STAFF RECOMMENDATION
1517 Paris Avenue
March 20, 2013

Application: New construction – detached accessory dwelling unit
District: Belmont-Hillsboro Neighborhood Conservation Zoning Overlay
Council District: 18
Map and Parcel Number: 11704026900
Applicant: Van Pond, architect
Project Lead: Sean Alexander, sean.alexander@nashville.gov

Roof Plan of Recent Addition

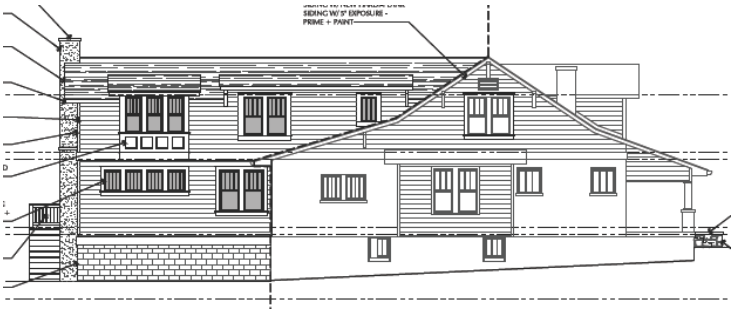
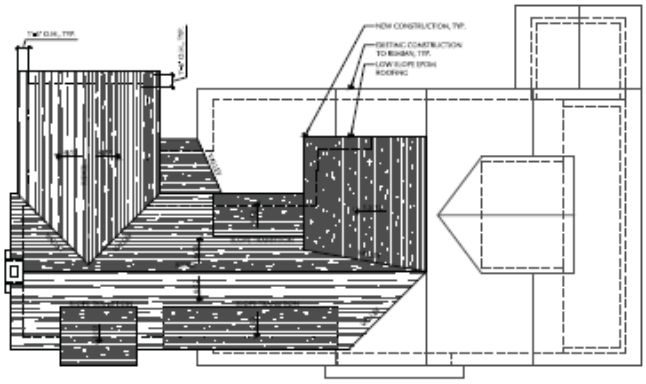
With the recently constructed two-story addition, the footprint of the primary building has a footprint size of two thousand, three hundred, ninety-seven square feet (2397 sq. ft.) leaving sixty-four percent (64%) of the lot remaining as open space. The DADU would bring the proportion of open space down to only fifty-five percent (55%).

By comparison, on nearby lots with historic houses and accessory buildings, the typical amount of open space is around seventy-two percent (72%). The lot at 1511 Paris Avenue has a lower amount of open space at sixty-one percent (61%), but it has a larger than average house and a smaller than average lot. A non-historic house at 1507 B Paris Avenue, constructed before the Neighborhood Conservation Zoning Overlay went in place, has the lowest amount of open space nearby with sixty percent (60%). The percentage of open space is easiest to calculate based on lot coverage alone but the massing of the structures on the lot should also be considered as "open" space is not just about green space. Although the proposed building is minimal, the rear addition recently added has two-stories and a partially above-ground basement. The additional height was allowable due to the drop in grade which kept the bulk of the addition hidden behind the primary building. The massing of the addition and the lot coverage of the full project, existing and proposed, all together significantly decrease the open space well below that found historically.

Because the lot already has little open space remaining compared to the historic properties nearby, and because the construction of the proposed DADU would leave the lot with the lowest proportion of open space among all nearby properties, both contributing and non-contributing, staff finds that the proposed DADU does not meet guideline II.B.1.b.

Recommendation:
Staff recommends disapproval of the application to construct a Detached Accessory Dwelling Unit at 1517 Paris Avenue, finding the proposed new construction exceeds the open space requirement of design guideline II.B.1.b of the Belmont-Hillsboro Neighborhood Conservation Zoning Overlay and Standard 8 of the Detached Accessory Dwelling Unit ordinance.

Proposed Site Plan

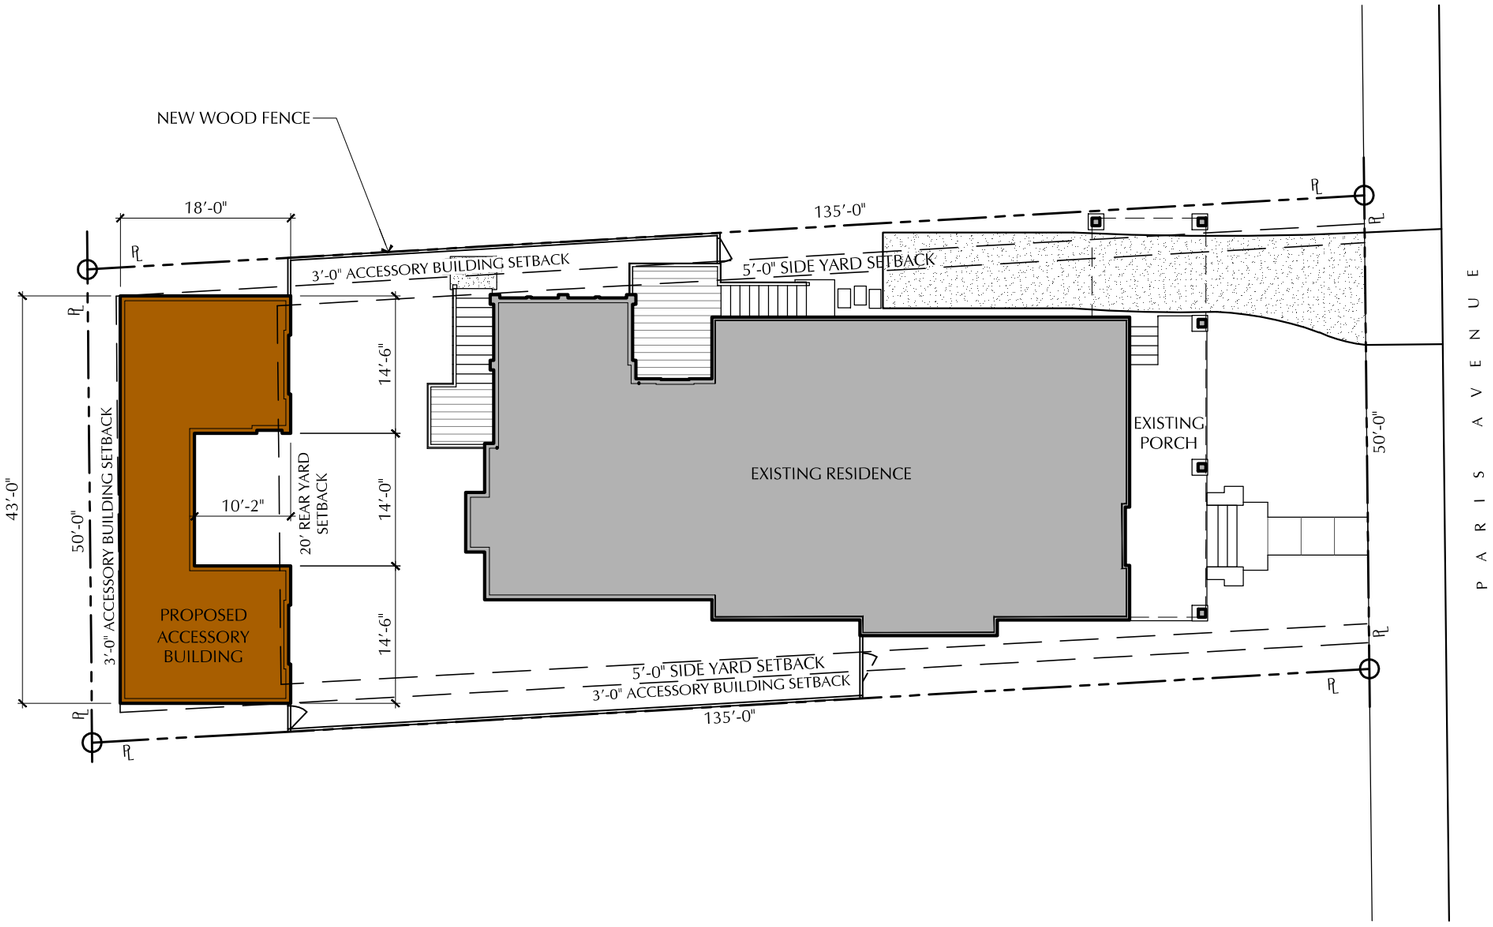
Location & Setbacks
The building is located at the rear of the lot as required by the design guidelines and the DADU standards. There is no vehicular access or associated parking. The building is setback more than the minimum of ten (10') from the primary house as required by the standards.

Roof Plan

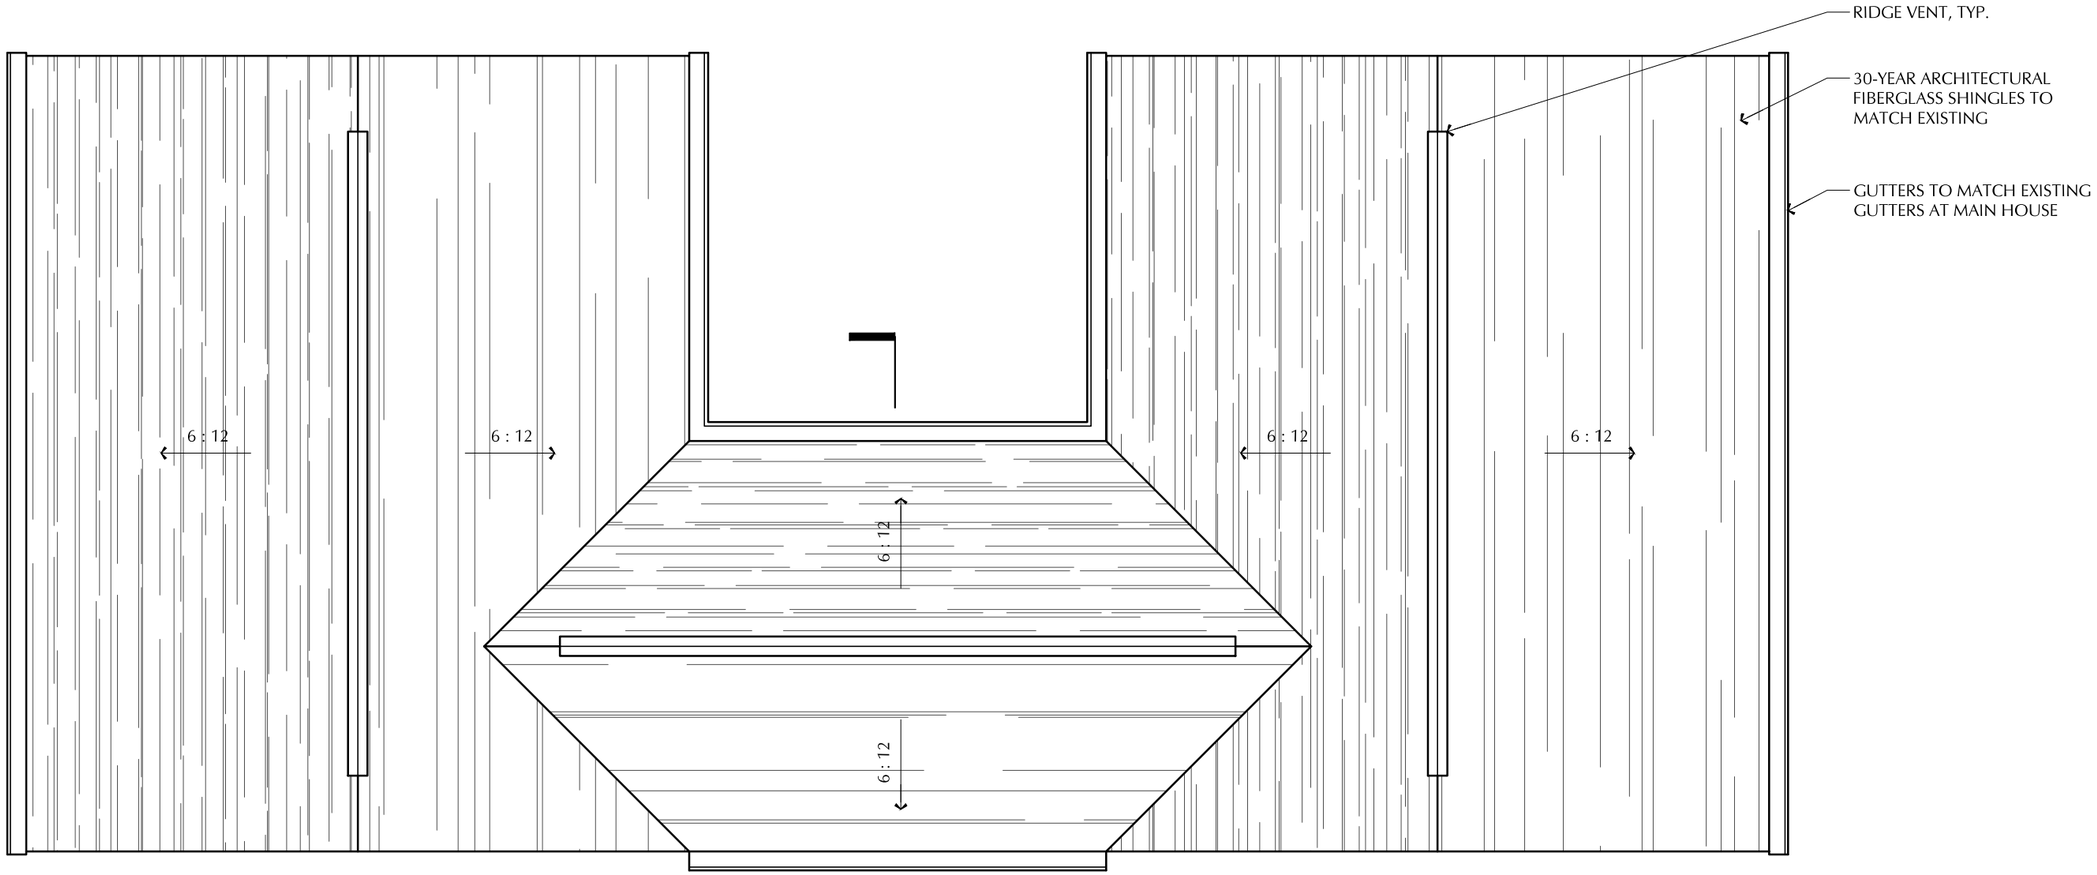
Roof Form
The roof of the new building would be U-shaped with two gables facing the house, and a lower "saddle" connecting them. The roofs will all have a 6:12 pitch. The roof forms are similar to that of the house, which has an 8:12 pitch primary gable and 6:12 front gabled dormer. Staff finds that the DADU roof would meet guideline II.B.1.e.

Rear Elevation (South)

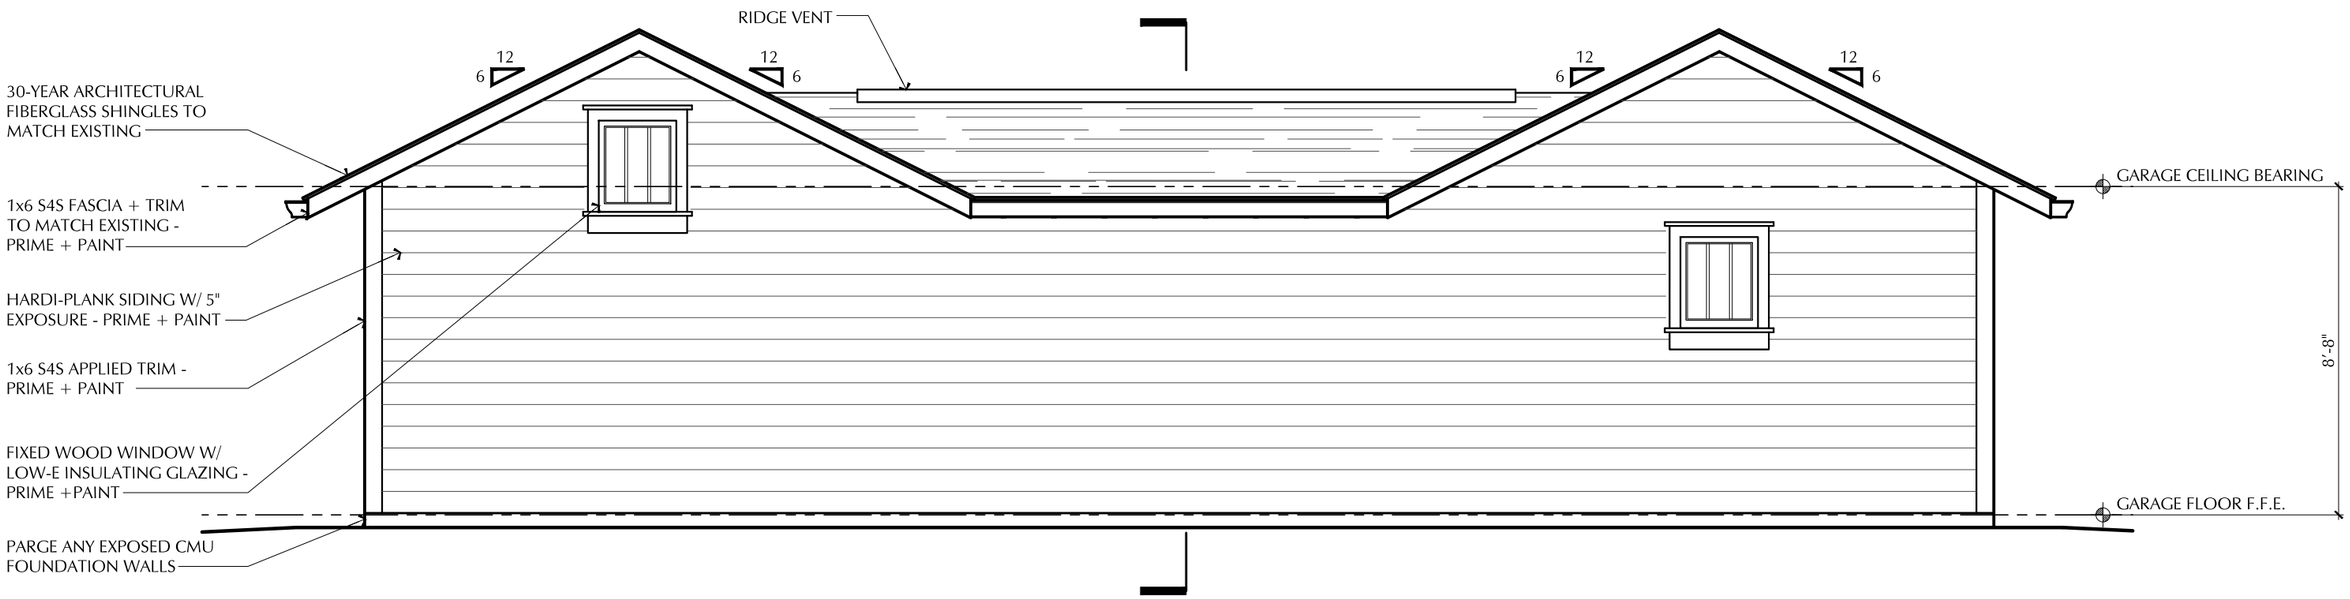
Proportion and Rhythm of Openings
The proportion of the majority of the windows and their placement is similar to what is found on the house with the exception of the rear elevation facing the alley. Typically, the commission has been more lenient about window requirements on outbuildings when they are located at the rear of the lot.
